**MONTGOMERY COUNTY HISTORIC PRESERVATION COMMISSION**  
**STAFF REPORT**

<b>Address:</b>	3807 Bradley Lane, Chevy Chase	<b>Meeting Date:</b>	2/22/2017
<b>Resource:</b>	<b>Gherardi House</b> <i>Master Plan Site #35/66</i>	<b>Report Date:</b>	2/15/2017
<b>Applicant:</b>	Angie Yu	<b>Public Notice:</b>	2/8/2017
<b>Review:</b>	HAWP	<b>Tax Credit:</b>	Partial
<b>Case Number:</b>	35/66-17A	<b>Staff:</b>	Michael Kyne
<b>PROPOSAL:</b> Rear addition and other alterations

**STAFF RECOMMENDATION**

# SITE PLAN - EXISTING AND PROPOSED

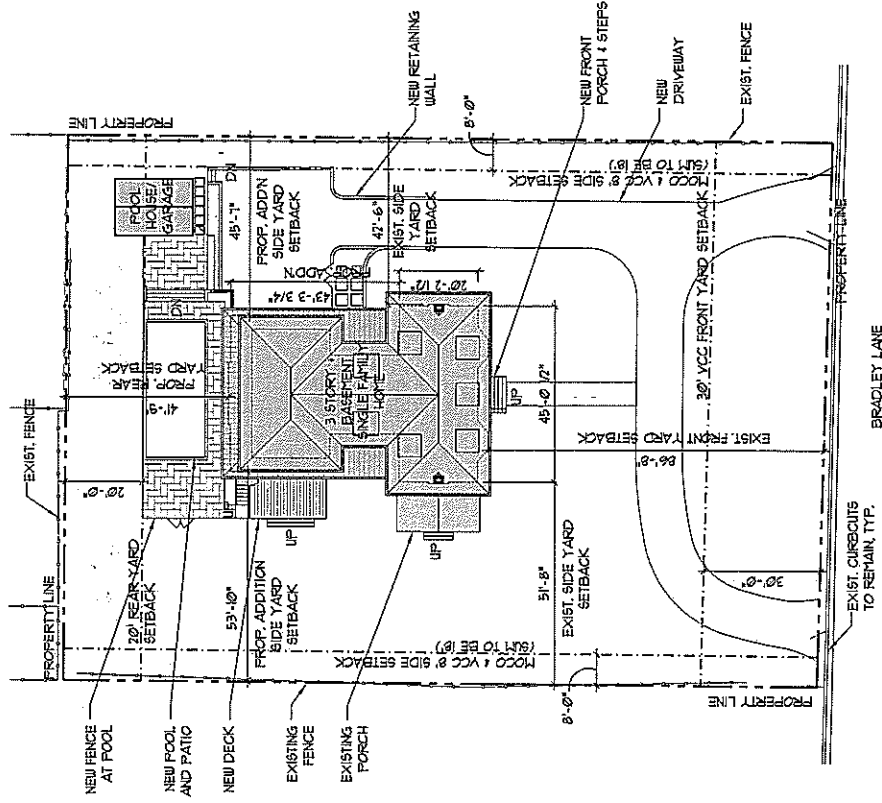
The applicant proposes to reconfigure the half-circle driveway at the front of the property, moving it closer to Bradley Lane and installing a bluestone walkway from the front entrance to the driveway.

The applicant has provided no information that indicates that the existing driveway is not historic. Absent information to the contrary, staff finds that the half-circle driveway and its relationship to the house (i.e., proximity to the front entry) is a character-defining feature of the subject property, and that, in accordance with the *Standards*, it should not be altered. The proposed alterations will be highly-visible from the public right-of-way, and, aside from introducing a new relationship of the driveway to the house, will introduce new hardscaping and require the removal of two mature trees from the front yard.

Staff finds that the proposed driveway/front walkway alterations are inconsistent with the Criteria for Approval, as they will remove features and alter spaces that characterize the historic property.

Two of the trees to be removed are from the right-side of the front yard (the space confined within the half-circle driveway). The applicant provided our office information from a certified arborist, indicating that the 24" maple tree to be removed is dead, dying, or a hazard, and received approval to remove the tree on February 7, 2017.

Aside from the 24" maple tree, there is only one other mature tree on the right-side of the front yard. That tree, which the applicant also proposes to remove, is a 15" crabapple tree. Staff finds that the removal of the 15" crabapple tree is inconsistent with the *Standards*, as it will leave the subject property with no mature trees on the right side of the front yard, altering spaces that characterize the subject property.

# **SOUTH ELEVATION - EXISTING AND PROPOSED** 3807 BRADLEY LANE | CHEVY CHASE, MD

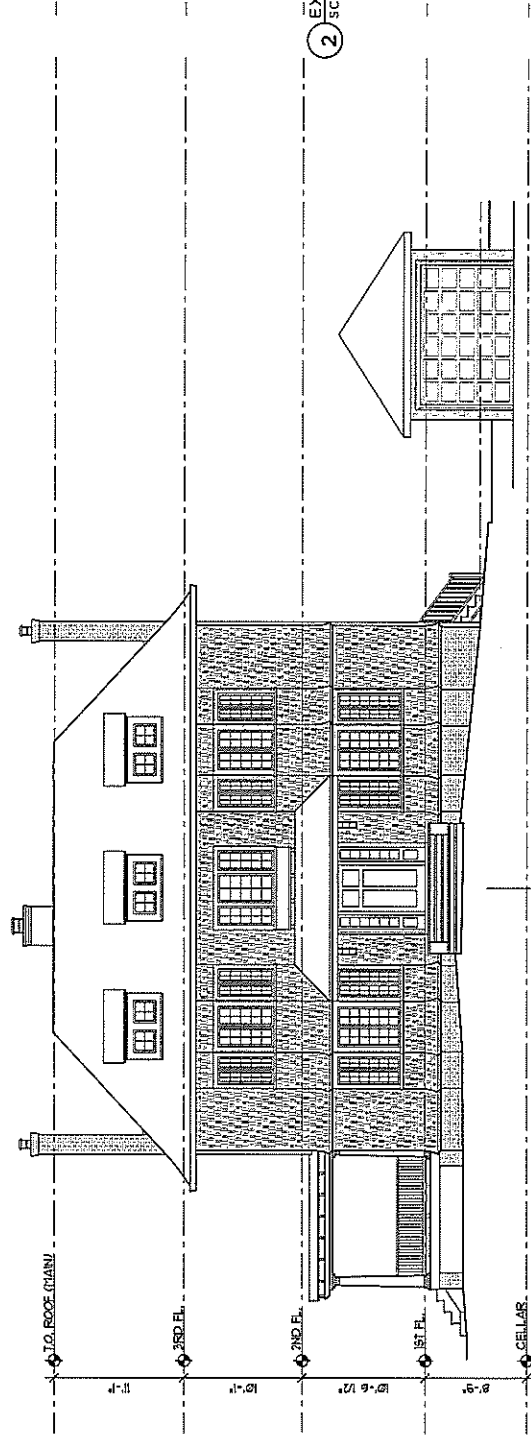
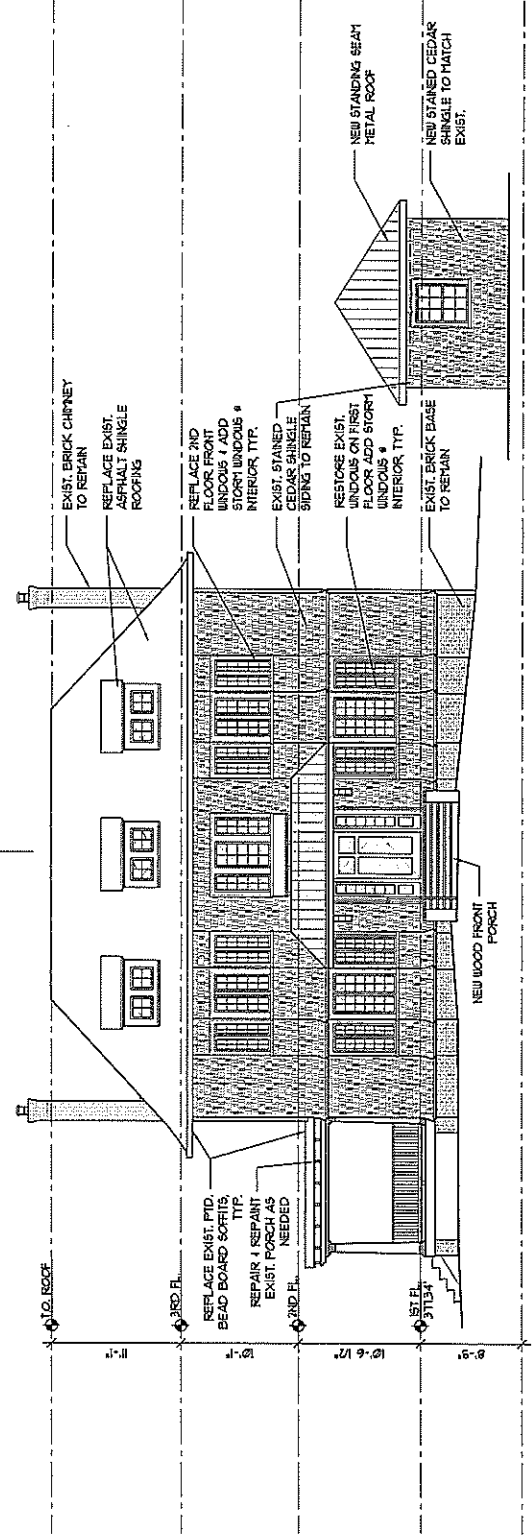
At the preliminary consultation, the majority of commissioners requested that shallower eaves be studied for the proposed rear addition. The eaves of the proposed rear addition have not been changed, and the applicant has not provided justification for retaining the previously proposed eave depth. Staff remains

concerned that the eaves of the addition are too deep, do not do enough to differentiate the addition from the historic massing, and are inconsistent with the Criteria for Approval. Staff recommends a condition of approval, stipulating that the eaves of the proposed rear addition will be shallower in order to adequately differentiate the addition from the historic massing, with final review and approval delegated to staff.

At the preliminary consultation, the applicant proposed to restore all of the windows on the historic house, including those on the second-floor of the front elevation. In the current proposal, the applicant proposes replace the windows on the second-floor of the front elevation of the historic house.

The windows that are proposed to be replaced are character-defining and are the most visible windows on the historic house. In accordance with the *Standards*, staff finds that, without evidence to suggest that the existing windows are non-historic and incompatible with the historic house, the windows should be retained, as replacing them would be detrimental to the preservation of the historic house.

1. The eaves of the proposed rear addition will be shallower in order to adequately differentiate the addition from the historic massing, with final review and approval delegated to staff.
2. The proposed garage door alterations are not approved. Final review and approval of the garage door alterations is delegated to staff.
3. The proposed fence at the swimming pool's perimeter will be wood, with final review and approval delegated to staff.
4. The proposed driveway alterations are not approved.
5. The proposed front walkway is not approved.
6. The proposed removal of the 15" dbh crabapple tree from the front yard is not approved.
7. The existing windows on the second-floor of the front elevation will be retained.
8. Details will be submitted for all new windows and doors, with final review and approval delegated to staff.

# EAST ELEVATION - EXISTING AND PROPOSED

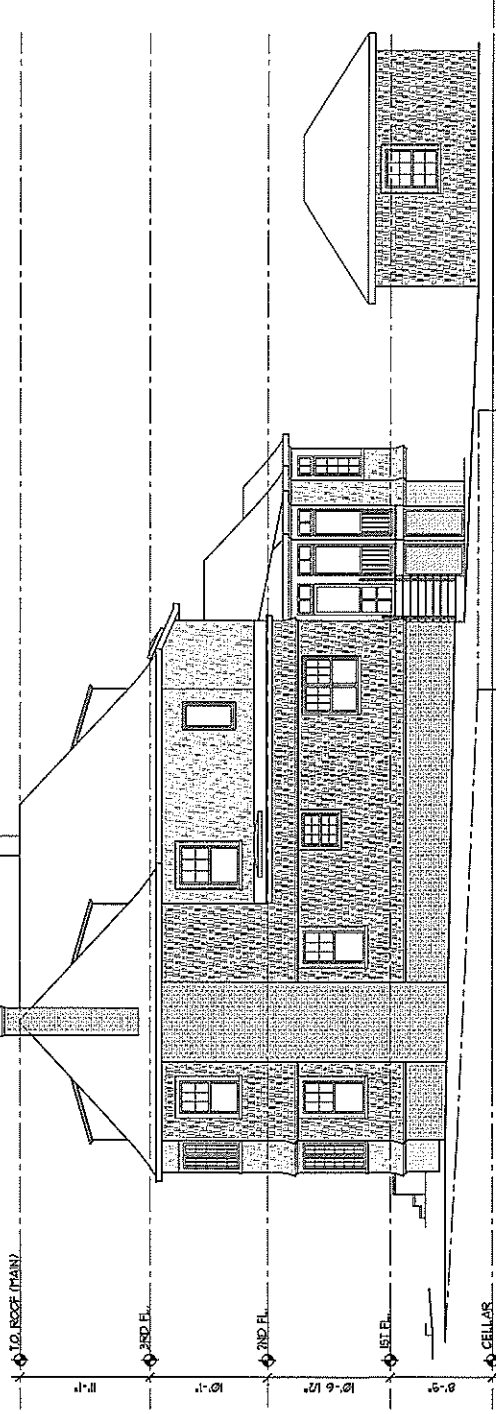
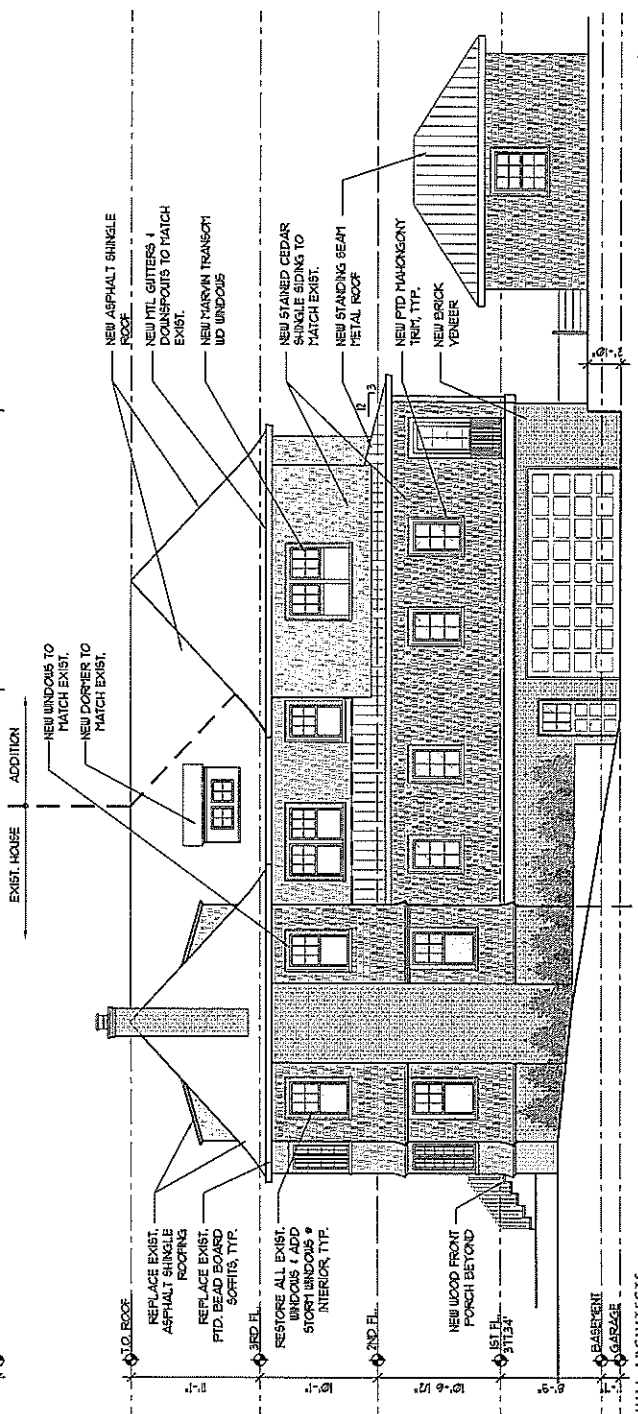
At the preliminary consultation, the applicant proposed to convert an existing fixed or casement window on the second-floor of the right-side elevation of the historic house into a double-hung window. The Commission voiced support for the proposed window conversion, due to its general lack of visibility and the compatibility of the proposed new window.

The applicant currently proposes to replace the existing double-hung window on the same elevation (forward of the fixed or casement window) with a paired double-hung window. Due to its location and general lack of visibility, the proposed window replacement will not remove features that characterize the historic property, in accordance with the *Standards*.

GARAGE- SOUTH ELEVATION

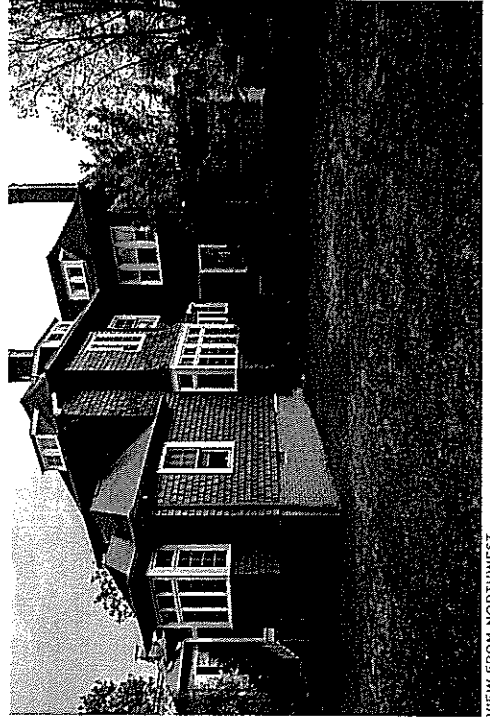
The applicant proposes to remove the garage door from the front elevation of the existing single-car garage, installing a double-hung window in its place, and to replace the asphalt shingle roofing with standing seam metal roofing to match that proposed for the first-floor of the proposed rear addition.

The submitted photographs suggest that the existing garage door is non-historic, and staff would support a compatible replacement; however, the garage is highly visible from the public right-of-way, and, without evidence to suggest that it is not original to the house, staff recommends that the garage retain some semblance of its historic function. Staff suggests that a compatible fixed garage door with lites might be an appropriate solution, but acknowledges that there may be other appropriate solutions as well. Staff asks the Commission to add a condition of approval, delegating final review and approval of the garage door alterations to staff.

Staff supports the proposed change in roofing materials, finding that standing seam metal roofing is appropriate for an accessory structure and compatible with the historic house, in accordance with the *Standards*.
